ITEM 5. DEVELOPMENT APPLICATION: 115-119 BATHURST STREET SYDNEY**FILE NO: D/2013/554****DEVELOPMENT APPLICATION NO: D/2013/554****SUMMARY****Date of Submission:** 26 April 2013. Additional and amended plans received 16 July and 13 August 2013.**Applicant:** Greenland Holding Group Overseas Investment Company Limited**Architect:** Crone Partners**Developer:** Greenland Holding Group Overseas Investment Company Limited**Owner:** Brookfield Bathurst Street Pty Ltd**Proposal Summary:** Stage 1 development application for a mixed retail, commercial, residential and hotel development. The proposal includes concept plan approval for the adaptive re-use of the existing 1939 heritage listed Sydney Water building as a hotel and partial demolition and redevelopment of the adjacent 1965 building (including an addition to its height) for retail, commercial and residential uses with a maximum building height of 235m (being approximately 54 levels). The development includes new pedestrian laneways and car parking for up to 244 vehicles. It is proposed to erect an 'exoskeleton' structure to sleeve the existing building and support the new addition (approximately 133 metres or 28 storeys) to it.

*

Figure 14: Proposed 'exoskeleton' structure

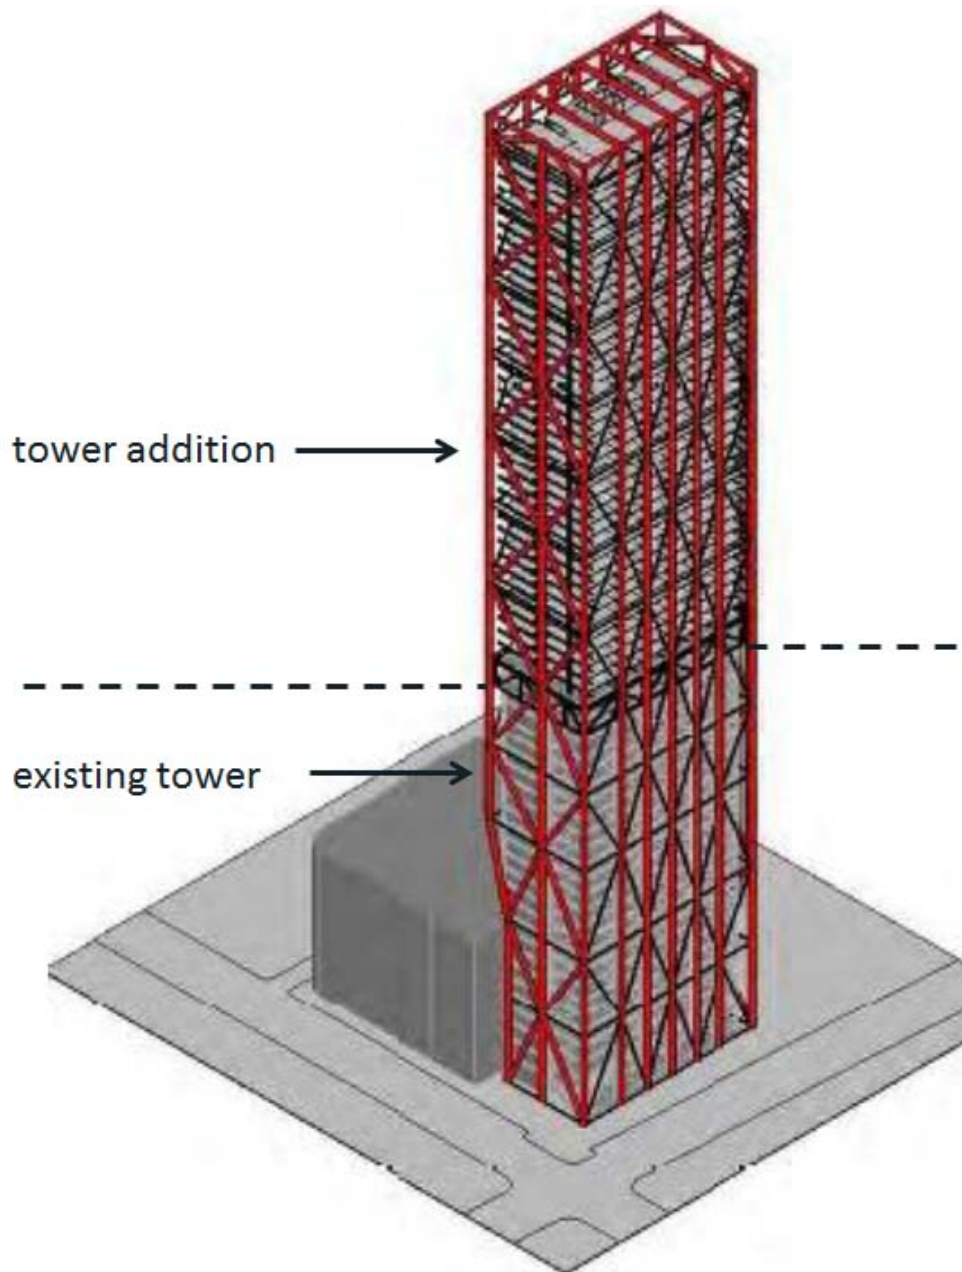
41. The proposed 'exoskeleton' structure will protrude into the existing building setbacks which (as discussed below) are already non-compliant on the north, west and south elevations. In addition (although preliminary in scope) the plans lodged with the application show the columns supporting the structure being partially located within the proposed new laneways and protruding through the commercial or 'creative hub' space located on levels 2-8 (refer to **Figures 15** and **16** below). The preliminary plans lodged with the application show that the structure could have a significant impact on the both the usability of this space and on the ground floor laneways. As such, an appropriate condition is recommended to ensure that the impact of the structure on the commercial or 'creative hub' space wrapping the car park is minimised.

42. In addition, the Heritage Council have stipulated that the separation between the bottom of the cantilever of the structure and the top of the highest point of the 1939 building must be at least 12500mm (refer to location of this on **Figure 17** below). This is also included as a condition and will need to be taken into account in the applicant's future design of the exoskeleton and building.

The competitive design process must highlight the need for the proposed exoskeleton structure, in particular crossbracing and structural connections, to minimise the impact on the usability of the podium floorspace wrapping the exterior of the above ground car parking currently indicated to be levels 2-8.

Figure 17 – site and predominant building wall height shown dashed along west side of Pitt Street

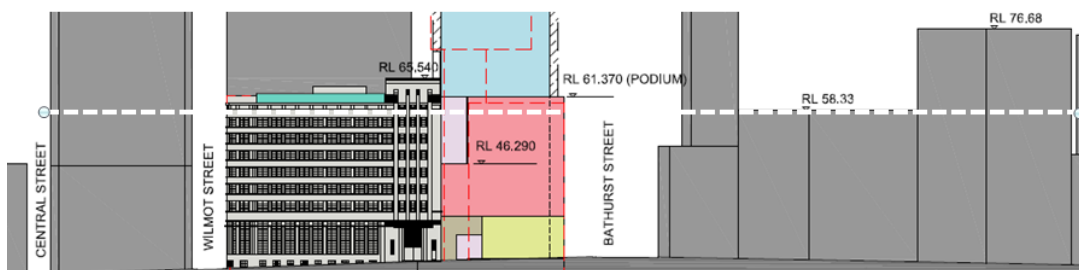
48. Taking account of the predominant building wall height along the west side of Pitt Street (see **Figure 17** below) this is considered acceptable.
